ROUTE U.S. 206 At Entrance To Stokes State Forest

CONTRACT NO. 120950525

ADDENDUM NO. 2

**ROUTE 206 AT THE ENTRANCE TO STOKES STATE FOREST
CONTRACT NO. 120950525
SUSSEX COUNTY**

ADDENDUM #3
ATTACHMENT #15

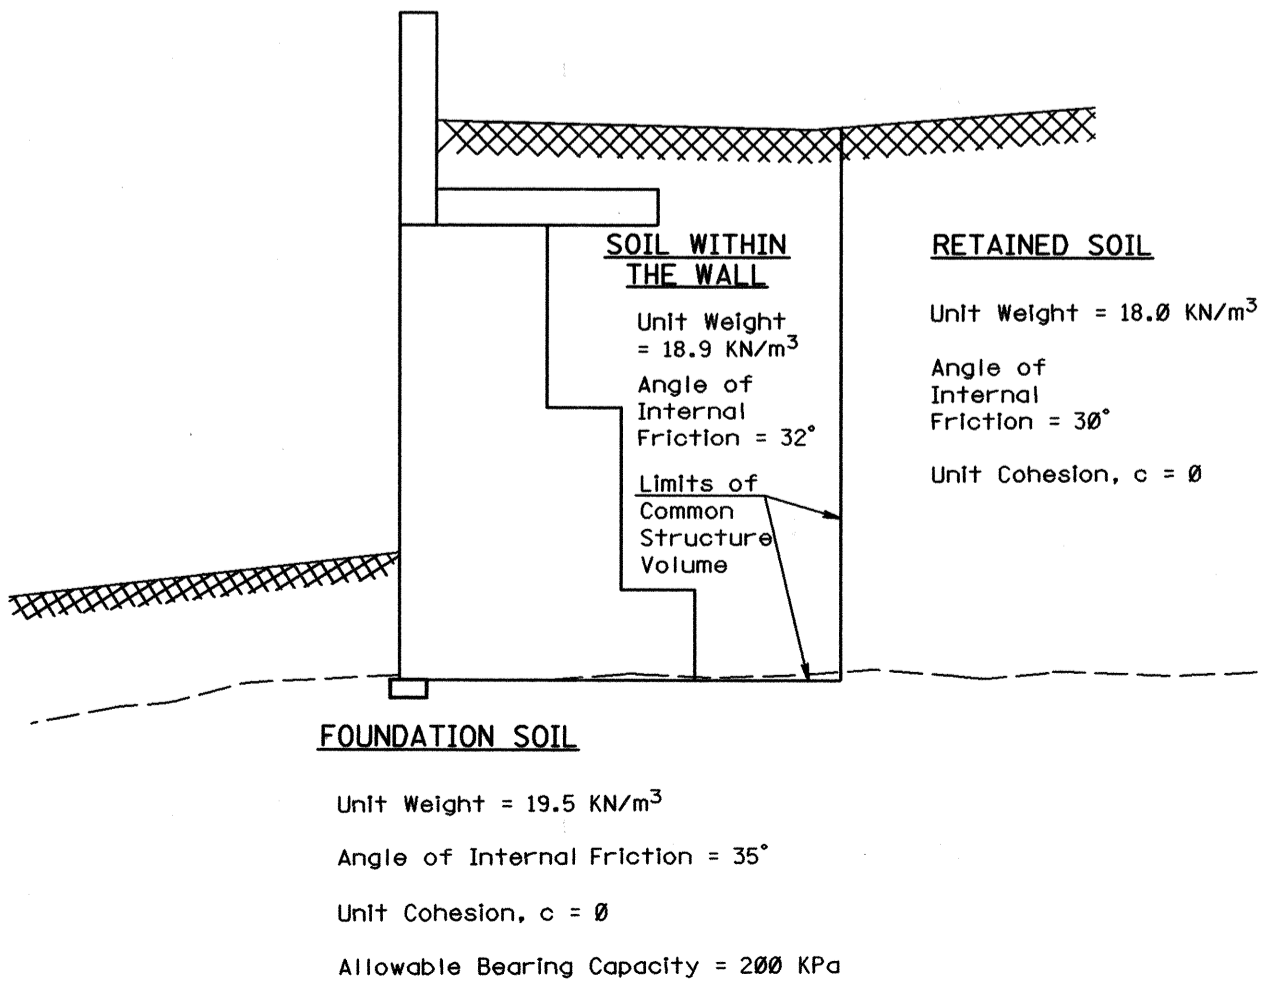
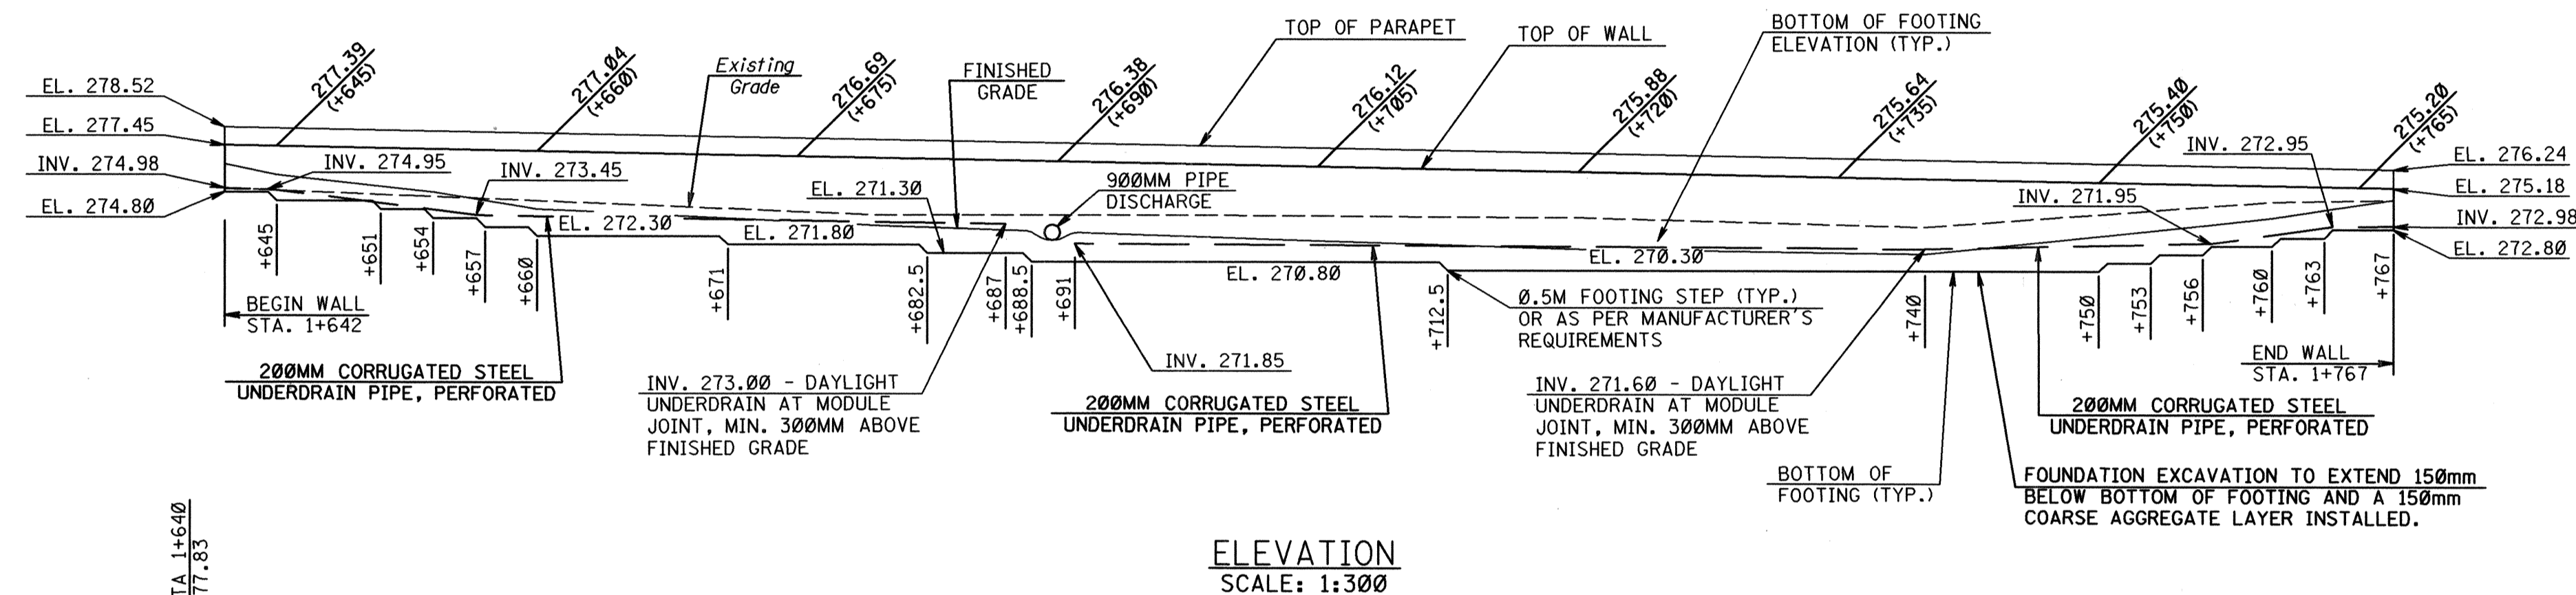
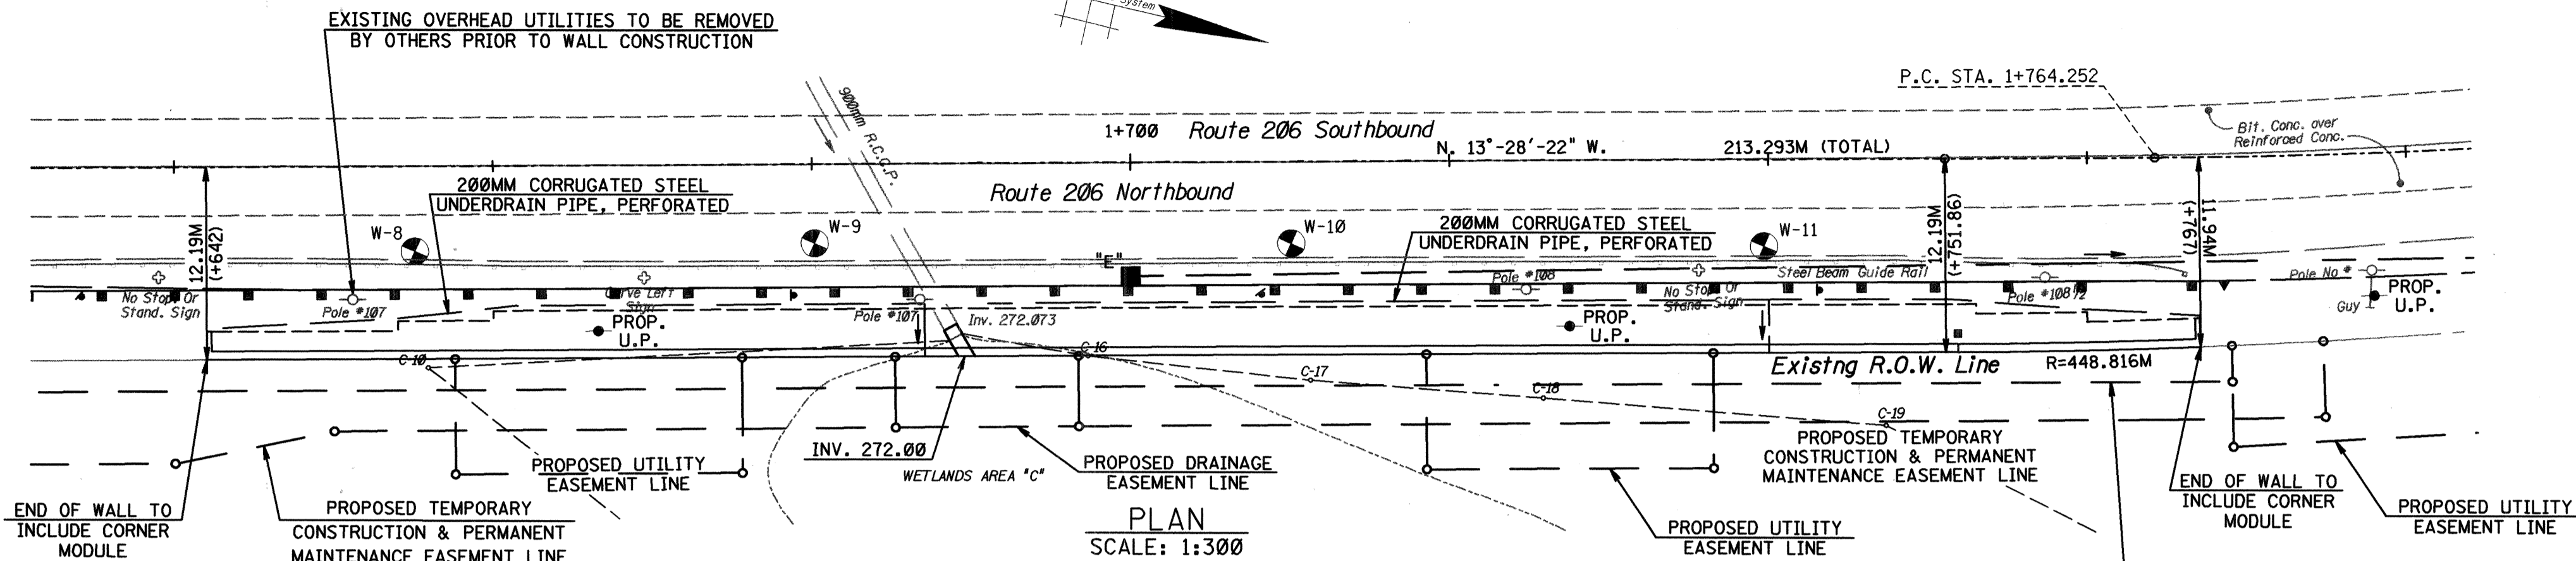
ATTACHMENTS 1 through 16 of Addendum 3, **REPLACE** the following original sheets:

ATTACHMENT NUMBER	ORIGINAL SHEET NUMBER
1	9
2	10
3	11
4	21
5	22
6	37
7	38
8	39
9	40
10	41
11	42
12	43
13	44
14	72
15	73
16	74

ESTIMATE OF QUANTITIES - WALL 2				
PAY ITEM NO.	STANDARD ITEM NO.	DESCRIPTION	UNIT	CONTRACT QUANTITY
115	5U02D	RETAINING WALL, LOCATION NO. 2	S.M.	710
117	2F10A	COARSE AGGREGATE LAYER	C.M.	135
118	2F12E	FOUNDATION EXCAVATION	C.M.	585
